Re: Fairfield Townhomes – Site Plan and Subdivision Plat
Application Number: DA-1556-25
Case Numbers: 2022-4012-00; 2022-3018-00

Technical Corrections Review

FAIRFIELD TOWNHOMES | SITE PLAN

A RESUBDIVISION OF A PART OF LOT 2, BLOCK 1, PAINTED PRAIRIE SUBDIVISION FILING NO. 5
 BEING A PART OF SOUTHEAST QUARTER OF SECTION 11, TOWNSHIP 3 SOUTH, RANGE 66 WEST OF THE 6TH P.M.,
 CITY OF AURORA, COUNTY OF ADAMS, STATE OF COLORADO
 SHEET 3 OF 15

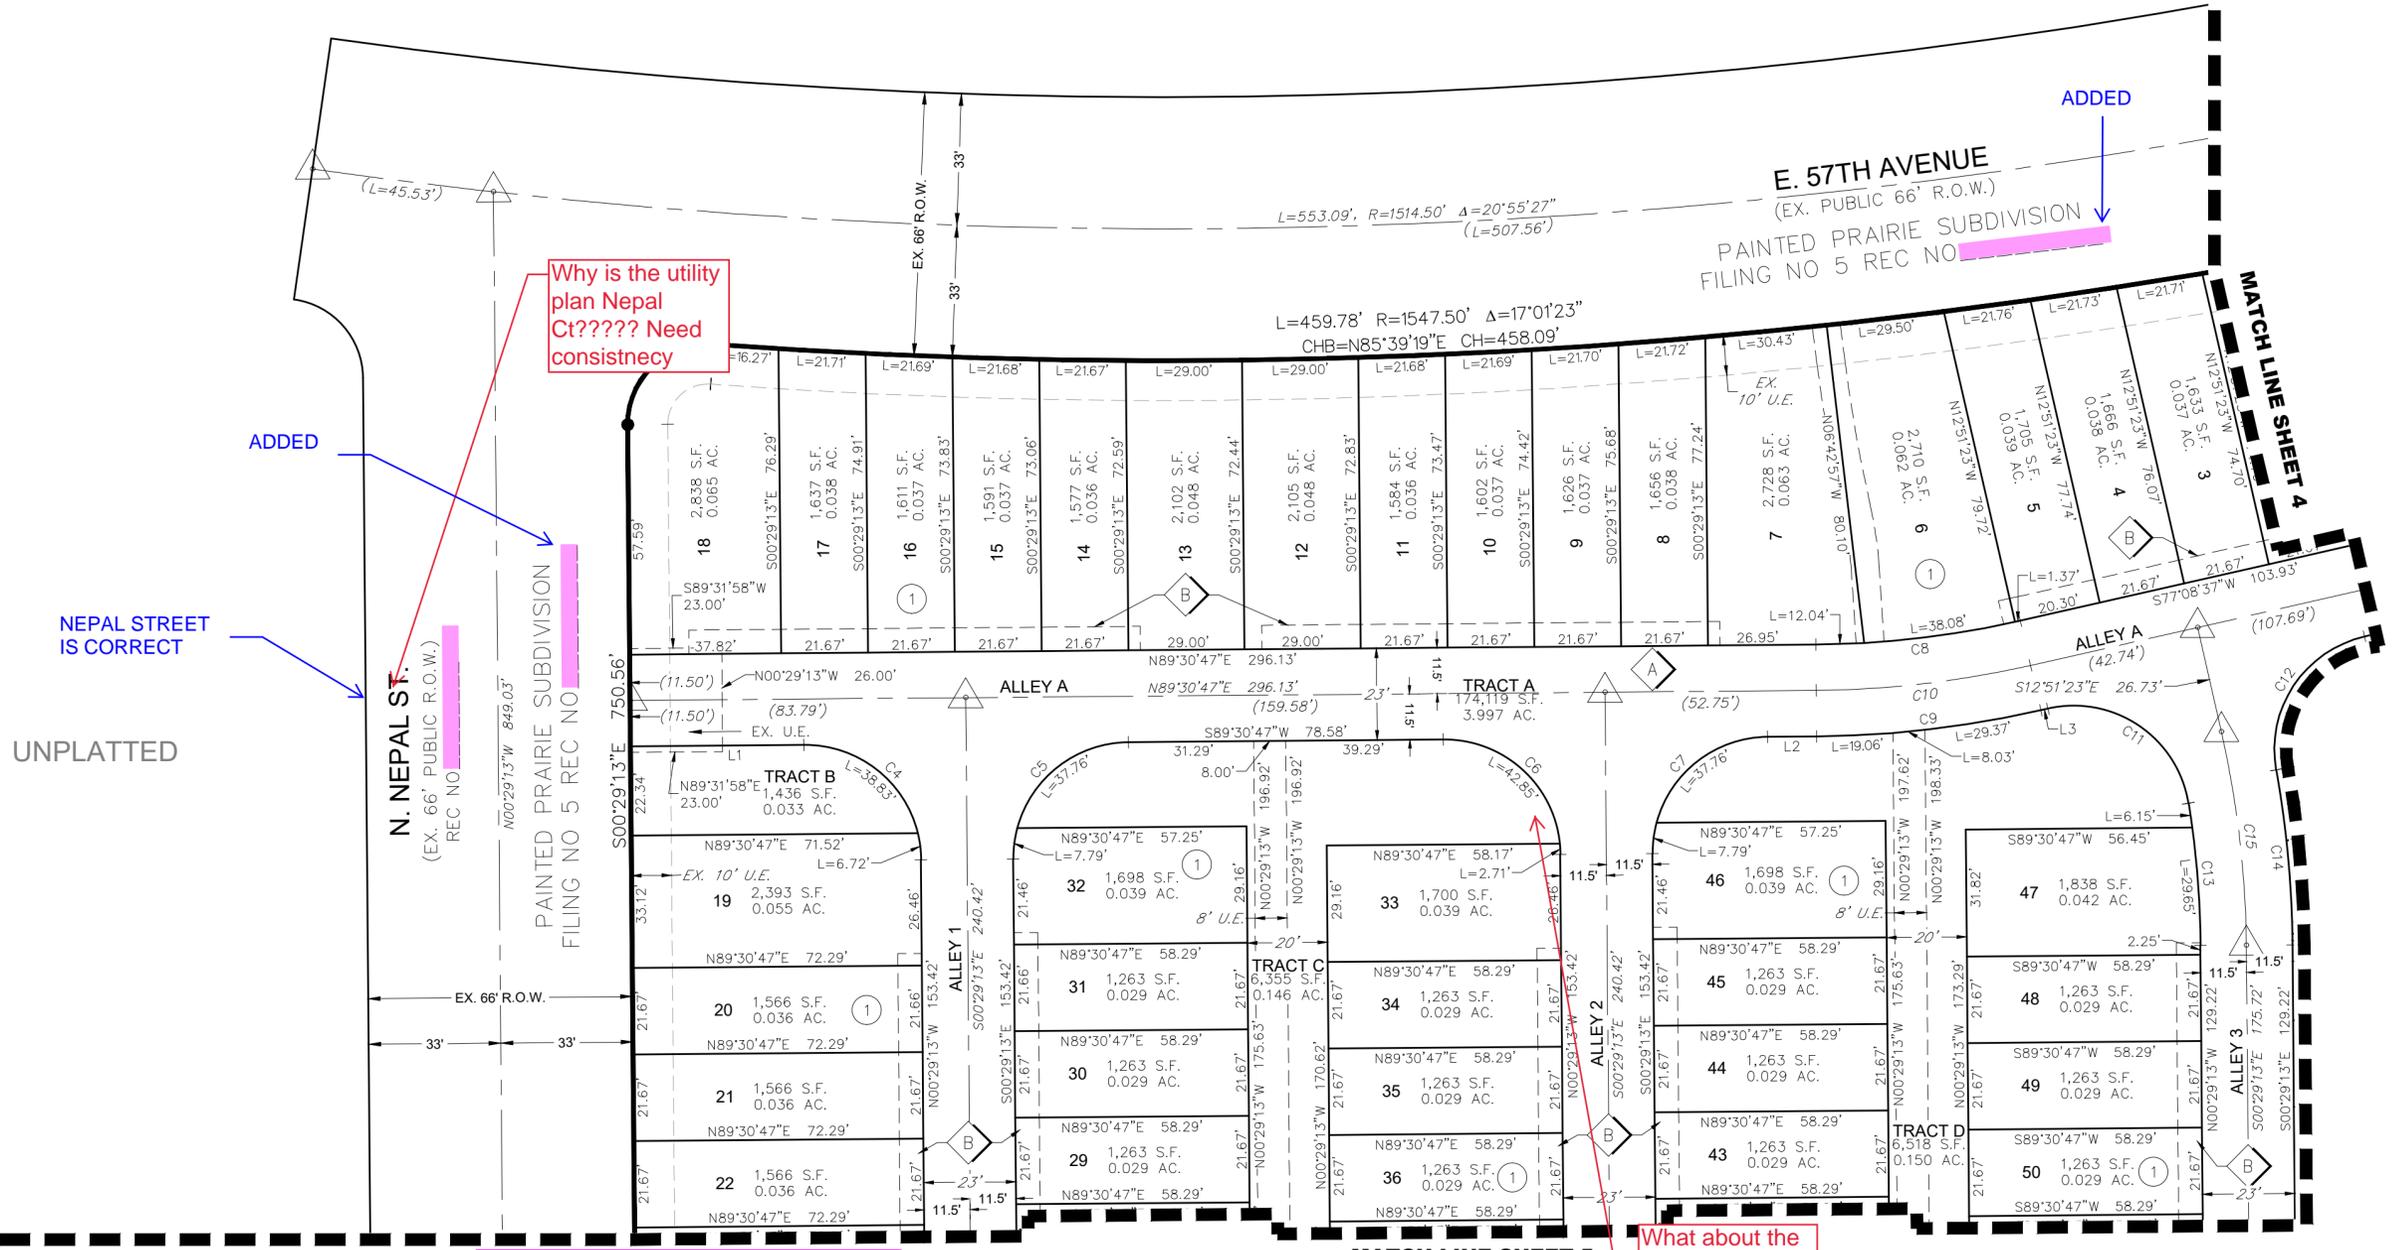
Why is the utility plan Nepal Ct????? Need consistency
